Brussels, 23.1.2009
C(2009)38 final

COMMISSION DECISION

**amending Decisions 2006/861/EC and 2006/920/EC concerning technical specifications
of interoperability relating to subsystems of the trans-European conventional rail system**

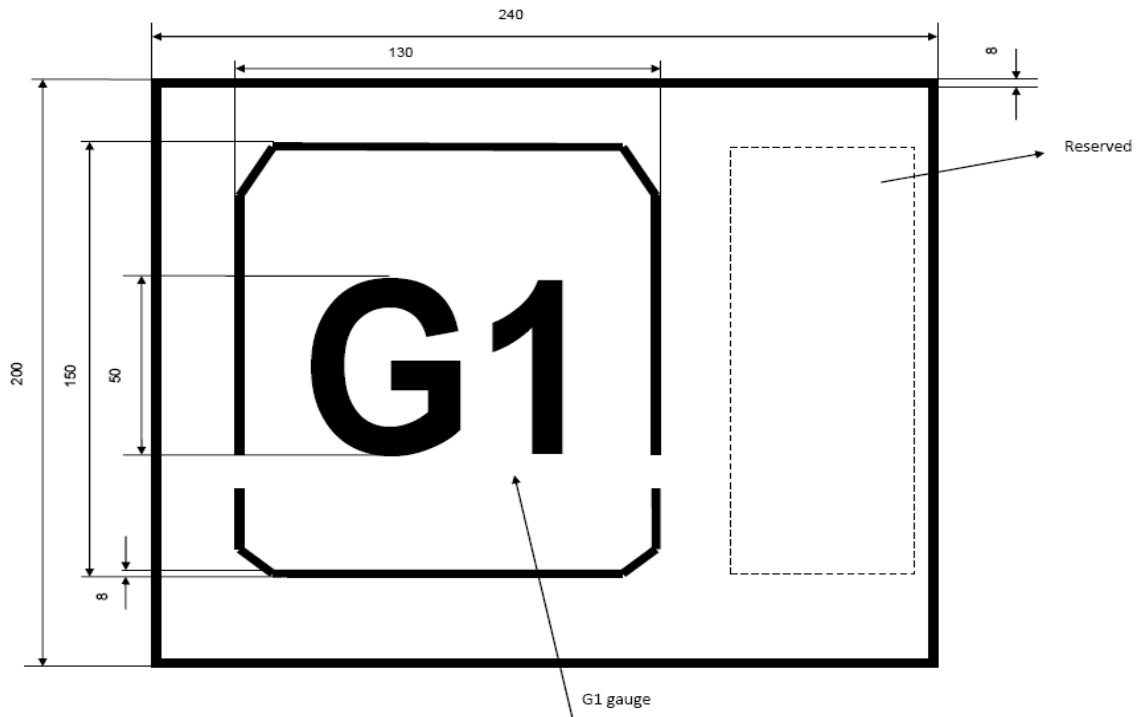
(a) in point 3, remark 4) is replaced by the following :

“4) Existing wagons that can be forwarded with the same loads as in S-traffic at 120 km/h, are already marked with the sign “***“ placed to the right of the maximum load markings; no additional wagons can be added to this category. “

(b) The following remark is added:

“5) New wagons with the braking performance of "S2"-wagons according to the table in section 4.2.4.1.2.2, that can be forwarded with the same loads as in S-traffic at 120 km/h according to particular specifications listed in Annex Y, shall have the sign “***“ placed to the right of the maximum load markings.”

“B.32. MARKING OF WAGONS GAUGE

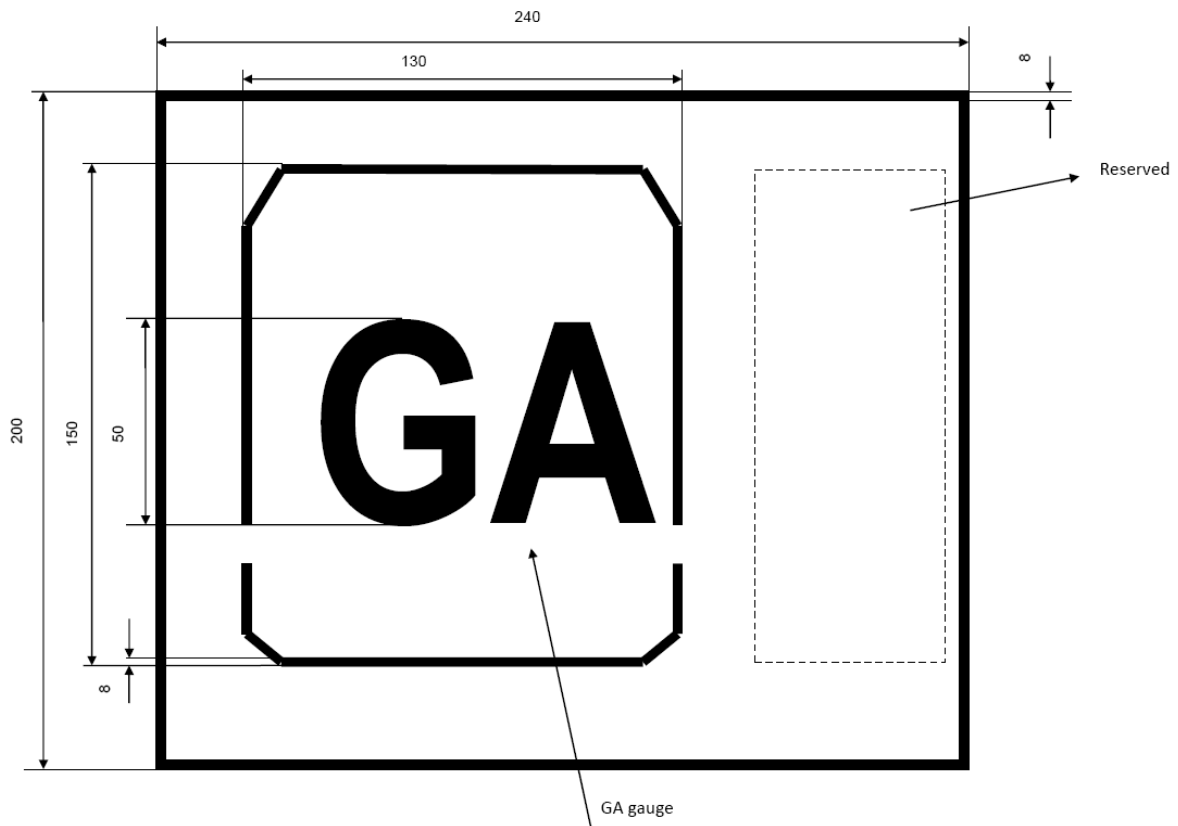
(c) point 32 is replaced by the following:

(1) Wagons built to gauge G1 will be marked as follows:

(2) Wagons built to gauges GA, GB or GC will be marked as follows:

Fig. 3 b - Relevage sur la voie
Re-railing

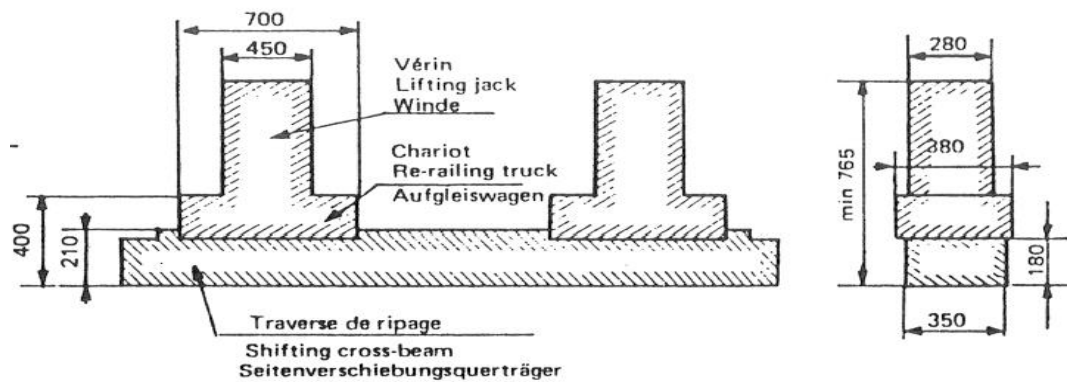
2.3. Jacking

In addition to the specifications of section 4.2.2.3.2.4 of this TSI, the compliance of the jacking with the following diagram is also required:

Figure 1 Rolling Stock Coordinates

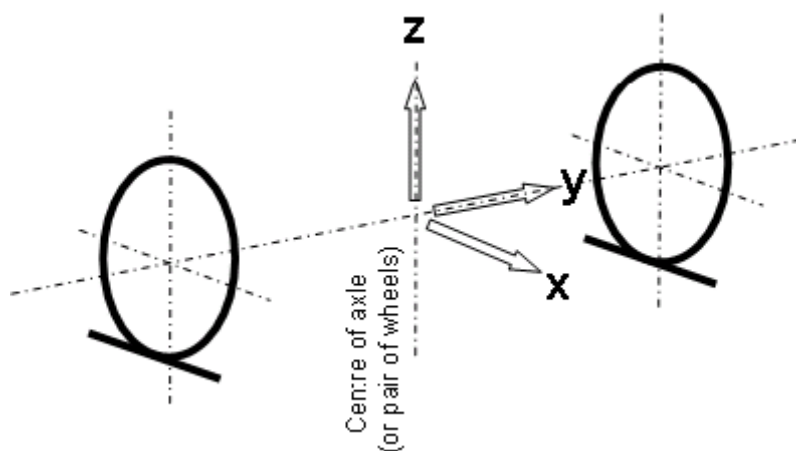
Rolling stock coordinates: rolling stock coordinates, figure 1, are based on the right hand rule Cartesian coordinate system, where the positive X-axis (longitudinal) is along the vehicle in the direction of travel, the Z-axis is vertically upwards and the origin is at the centre of the wheelset axle. The Y-axis is the lateral axis.

Figure 2 Dimensions and position of the target area (TA) in the XY plane (viewed from below)

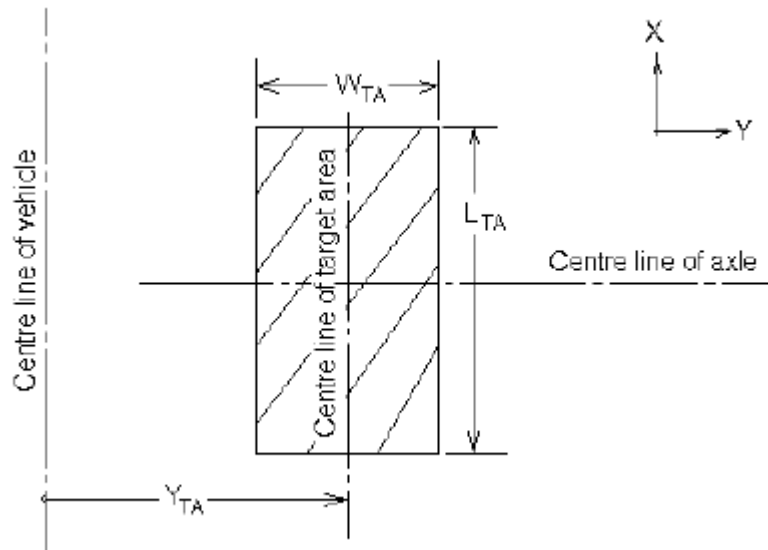
The target area is set in space relative to the axle dimensions, and defines an area in which a HABD can focus to monitor the temperature of an axle box. Figure 2 shows

the position and minimum dimensions of the target area using rolling stock coordinates.

- have a lateral width, W_{TA} , greater than or equal to 50 mm
- have a longitudinal length, L_{TA} , greater than or equal to 100 mm

In the XY plane the centre of the target area shall be positioned at a lateral distance, Y_{TA} , relative to the centre of the axle (or centre of a pair of wheels at the same position), where 1065 mm is less than or equal to Y_{TA} and Y_{TA} is less than or equal to 1095 mm. In the longitudinal axis the centre of the target area shall be congruent with the centre line of the axle.

Figure 3. Dimensions of the prohibitive zone (PZ) in the XY plane (viewed from below) showing a possible position of a target area

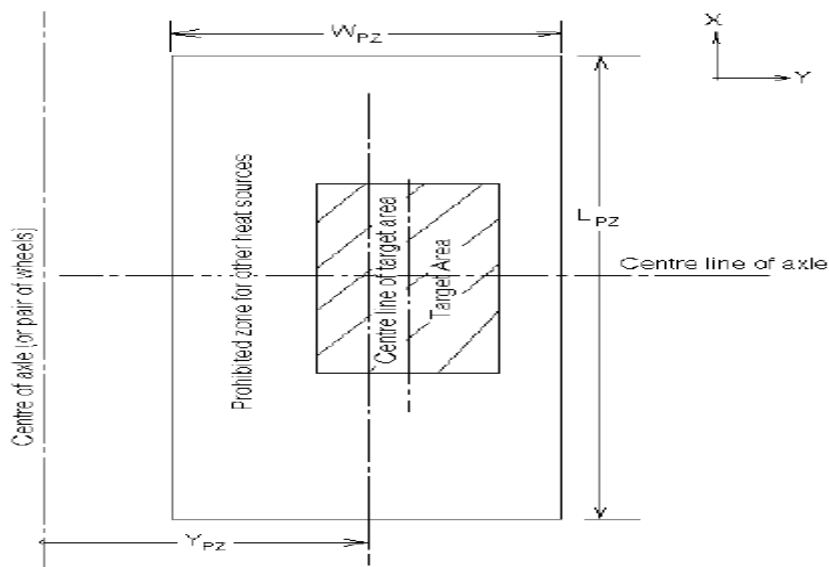
The prohibited zone is defined by a rectangular area, which includes the target area, and is extended vertically to form a virtual cuboid. The dimensions of the cuboid are LPZ and WPZ in the XY plane and HPZ in the vertical axes. Figure 3 shows a possible position of the target area in the prohibitive zone using rolling stock coordinates.

- lateral width, WPZ, greater than or equal to 100 mm
- longitudinal length, LPZ, greater than or equal to 500 mm
- vertical height, HPZ, starts at a point in the XY plane immediately above the HABD and ends at either the height of the target area, the height of a thermal shield or the height of the vehicle.

- in the lateral direction, YPZ = 1080 mm \pm 5 mm measured relative to the centre of the axle (or centre of a pair of wheels at the same position)
- in the longitudinal direction it shall be congruent with the centre line of the axle \pm 5 mm.
